Interactive comment on “Quality assessment of Dobson spectrophotometers for ozone column measurements before and after automation at Arosa and Davos” by René Stübi et al.

Reply to referee#1 comments on AMT-2020-441 manuscript, “Quality assessment of Dobson spectrophotometers for ozone column measurements before and after automation at Arosa and Davos” by René Stübi et al.”

Fig. 1. Figure outliers_removal

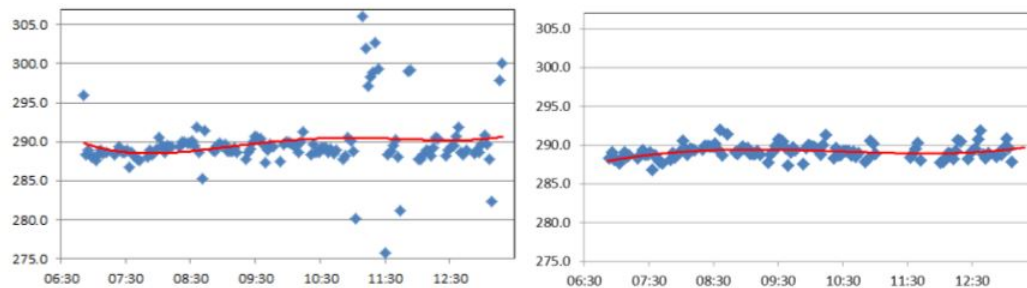
Comment 1. 3.1 Data quality control: I like the detail in the explanation of the automated procedure. I would have liked to have seen a daily record before and after this

procedure was applied.

Reply: It would have been difficult to illustrate the procedure with a single figure since many atypical cases regarding the outliers are of interest. The selection of the parameters (polynomial function, thresholds) were empirically determined by trial and error. An example (as illustrated in Figure 1) would have been possible but it does not show the variety and complexity of outliers' detection.
